Change Notice

MBN & WB Series

Changes for AT412 Caps for MBN & WB Series Pushbuttons

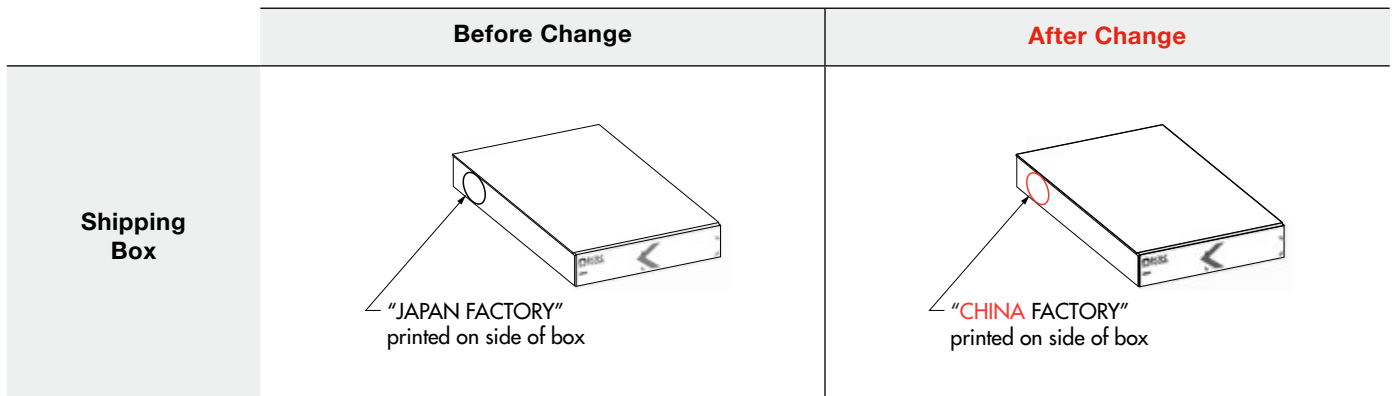
2. The location of production for AT412 caps will be changing. The boxes in which the products are packed for shipping will now read "CHINA FACTORY" instead of "JAPAN FACTORY." This change will apply to both standard and custom AT412 caps. The effected standard part numbers are listed on page 1.
